# Septic Site Evaluation

246-24-000181-EVAL

Date evaluation denied: 08/13/2024  
Application status: Denied  
Work description: Robbins - Site Evaluation

# Site Plan For Site Evaluation

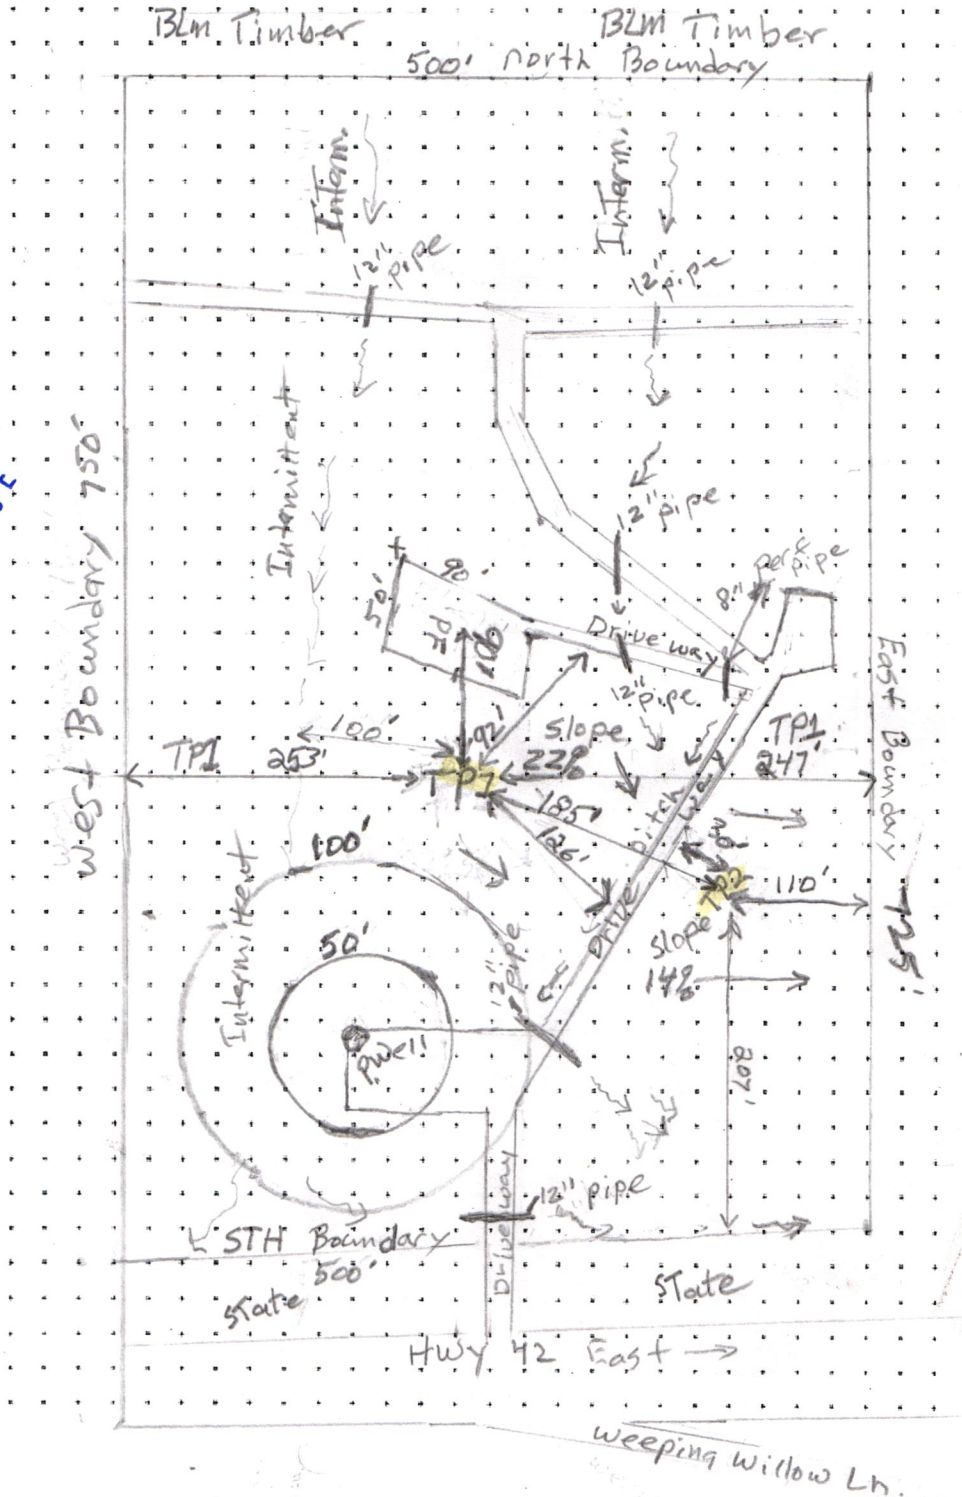
-Denied ESD on Steep Slope  
-Need more pits in less steep area or have ESD  
in those areas, down slope  
-WATER

Other Site Notes: Pit #2 levels out down slope, need additional pits to approve standard, Denied for esd - steep slope 35% = 40' ESD  
 Pit #1 ~35%, downslope gets steeper, upslope approximately 30-35% undulating, need pits to prove ESD.
